### CITTY OF POMONA • PUBLIC WORKS DEPARTMENT ENVIRONMENTAL SERVICES DIVISION Storm Water Facility Inspection/Site Visit Report Form

Job Address 1810 S. RESERVOIR ST - TRIANGLE T

#### Stormwater Inspection 1810 S Reservoir St Pomona, California 21AUG08

#### PHOTOGRAPH 8.

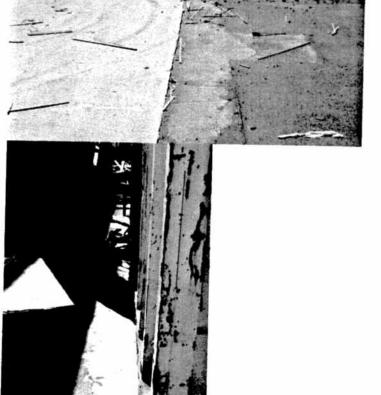
View of debris from the hopper on the SW side of facility.

The tenant was instructed to sweep up debris on a more regular basis.
